CITY OF ALBUQUERQUE

**RE: Presbyterian Hospital
Grading & Drainage Plan
File:K15D005F
Revised Plan Dated 11-17-2016**

**RE: Presbyterian Hospital
Grading & Drainage Plan
Stamp Date: 10-31-2016 (File:K15D005F)**

GRADING &
DRAINAGE PLAN

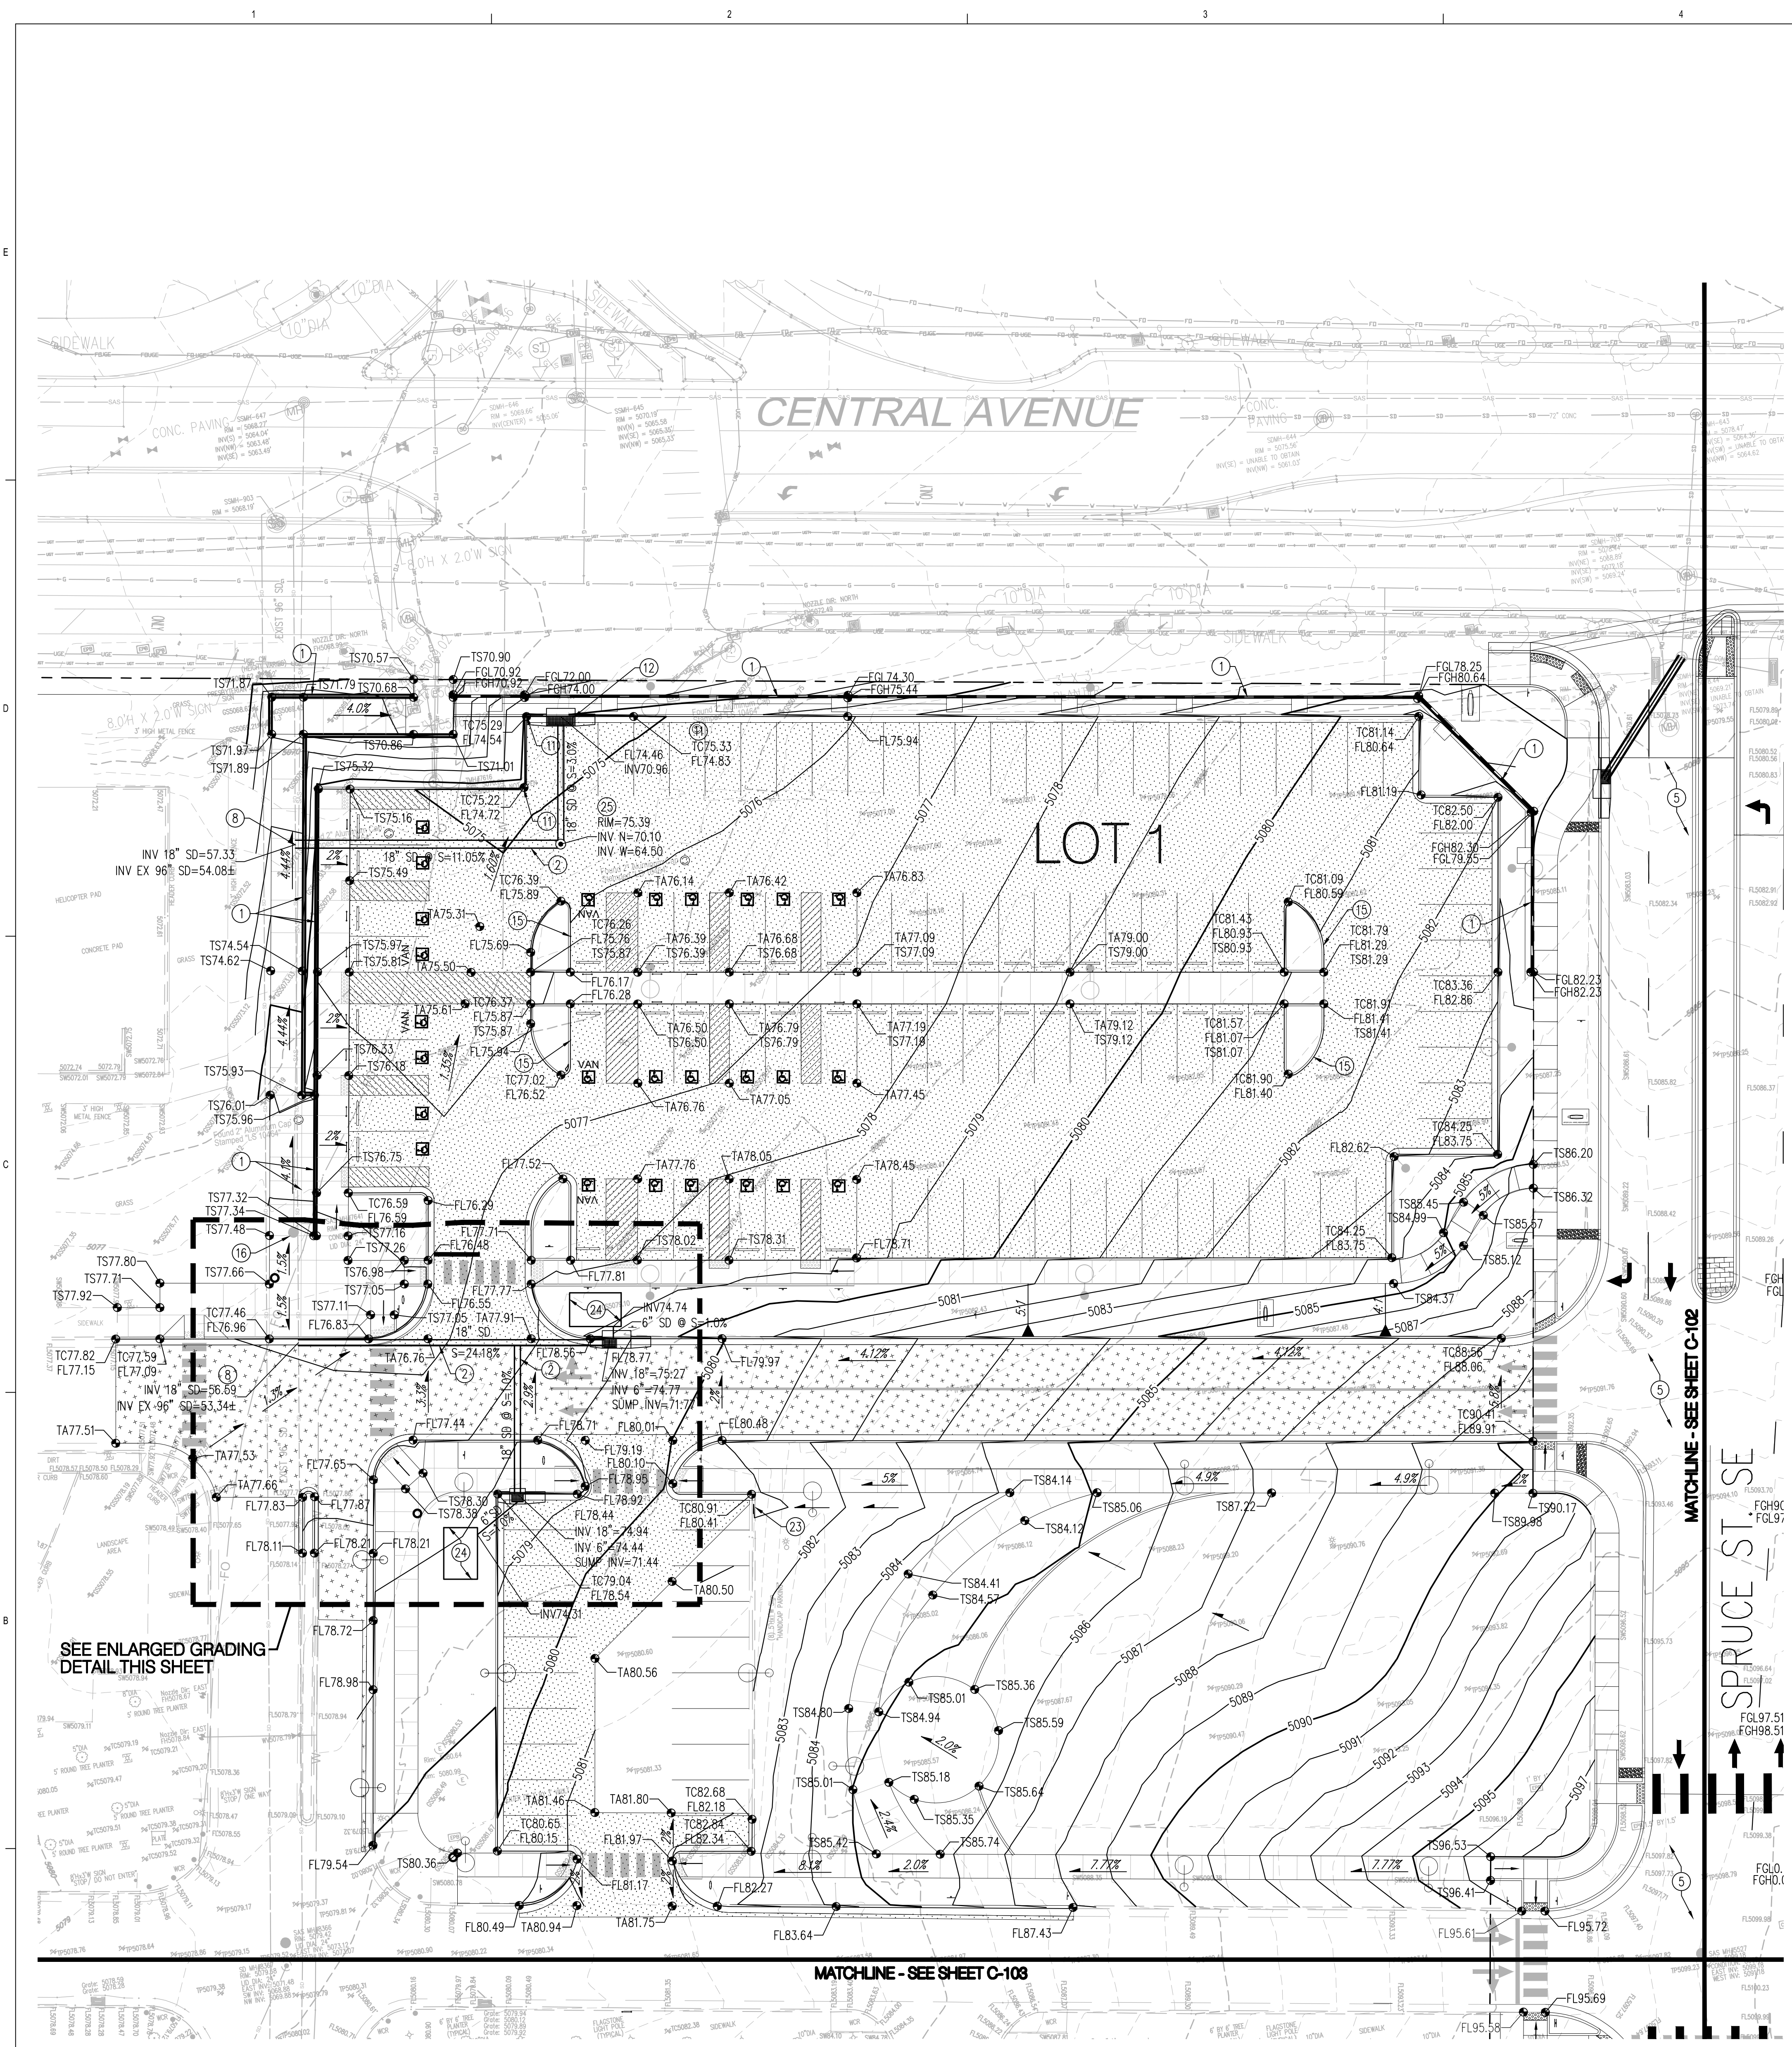
1. Consider incorporating a design element to reduce debris from reaching the underground water quality chambers to reduce the maintenance burden/clogging (not a requirement).
2. The improvements on Lots 3 and 4 do not include any water quality elements, except minimal capture in the parking islands. The large inlet upstream of the connection to the City's storm drain needs to be a water quality inlet. This can be accomplished with a hooded outlet or other similar low cost, yet reliable option.
3. Ensure that the Contractor has elevation data to set the bottom of the underground chambers. The final elevations should be included in the as-builts.
4. Provide calculations for the rundown and sidewalk culvert array capacity.
